RENESAS TECHNICAL UPDATE

Product Category	MPU/MCU	Document No.	TN-RX*-A0289A/E	Rev.	1.00
Title	Capacitance Reduction Characteristics of Capacitive Touch Sensing Unit (CTSUs) due to Power Supply Ripple Noise		Information Category	Technical Notification	
Applicable Product	RX671 Group	Lot No.	Reference Document	RX671 Group User's Manual Hardware Rev.1.20 (R01UH0899EJ0120)	
		All

Figure 1 Measurement circuit

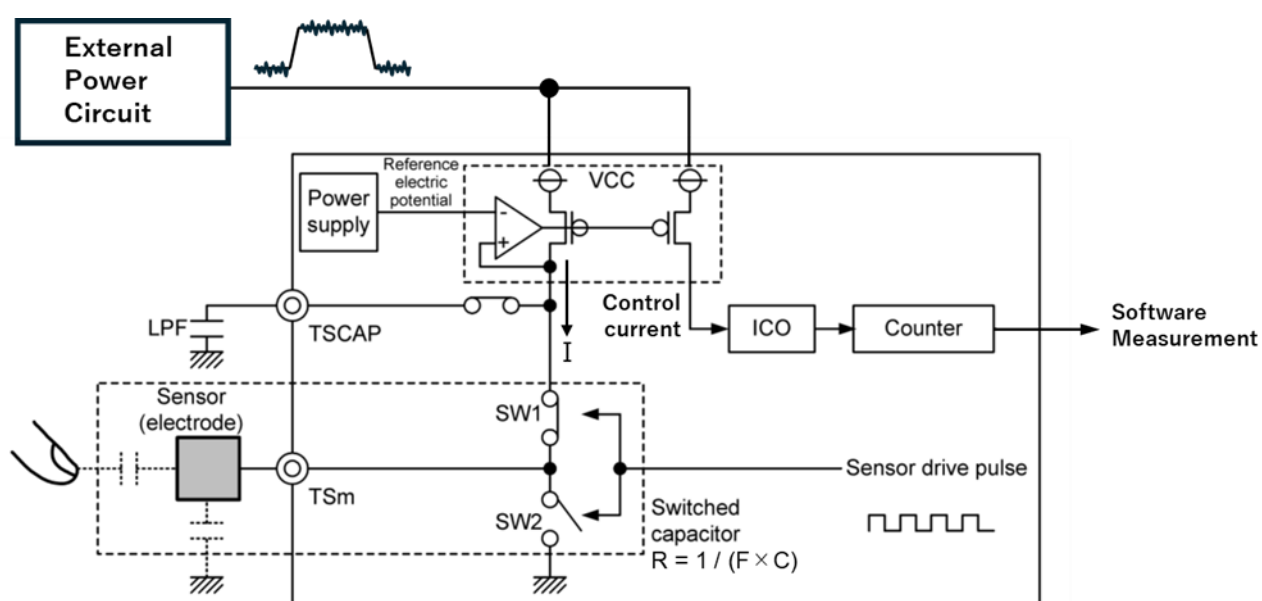
The superimposition of ripple noise on the VCC power supply might affect the CTSU circuit control current and cause a decrease of the capacitance value measured on the TSm terminal, depending on the noise frequency distribution and maximum amplitude. Please consider the provided reference characteristic data when designing the VCC power supply circuit, and adjust the CTSU operational settings as needed with referring the following application note (R30AN0453)

For the calculation method of the measured capacitance value of the CTSU when ripple noise is superimposed, please refer to “3.4 Touch Parameter Adjustment” “(1) RX130 Capacitance Measurement Value Conversion Formula” in the application note “Capacitive Touch Ripple Countermeasures Guide (R30AN0453)”. However, replace V_{dc} (typ.) [V] with 1.18V.

Figure 2. Measured capacitance reduction amount

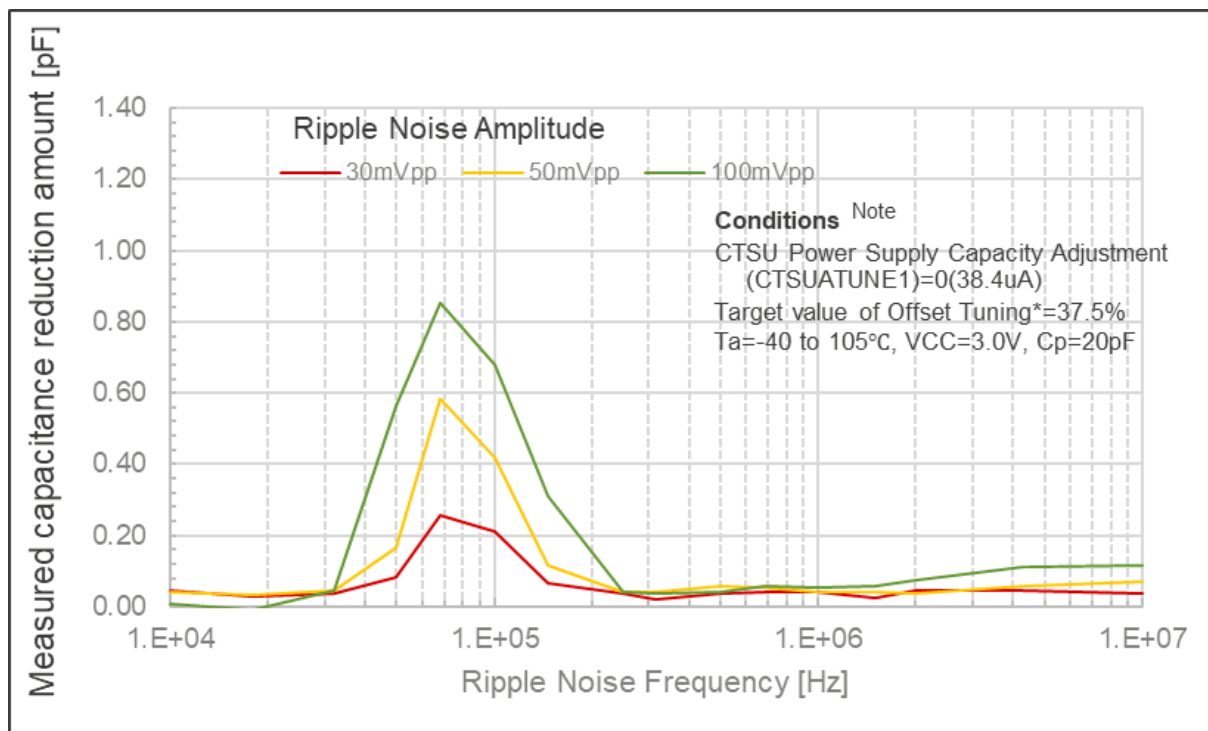
Item		Symbol	min	typ	max	Unit	Test Conditions (Ripple noise amplitude)
Measured capacitance reduction characteristics (Notes 1)	Ripple Noise Frequency < 20kHz	C_{down}	—	—	0.05	pF	100mVpp
	20kHz ≤ Ripple Noise Frequency ≤ 300kHz		—	—	0.26		30mVpp
			—	—	0.59		50mVpp
			—	—	0.86		100mVpp
	300kHz < Ripple Noise Frequency		—	—	0.12		100mVpp

- When using the Self-capacitance method (CTSUCR1.MD1= 0).
- When CTSU Power Supply Capacity Adjustment is Normal output (CTSUCR1.ATUNE1 = 0).
- When the target value for offset adjustment is 37.5%.
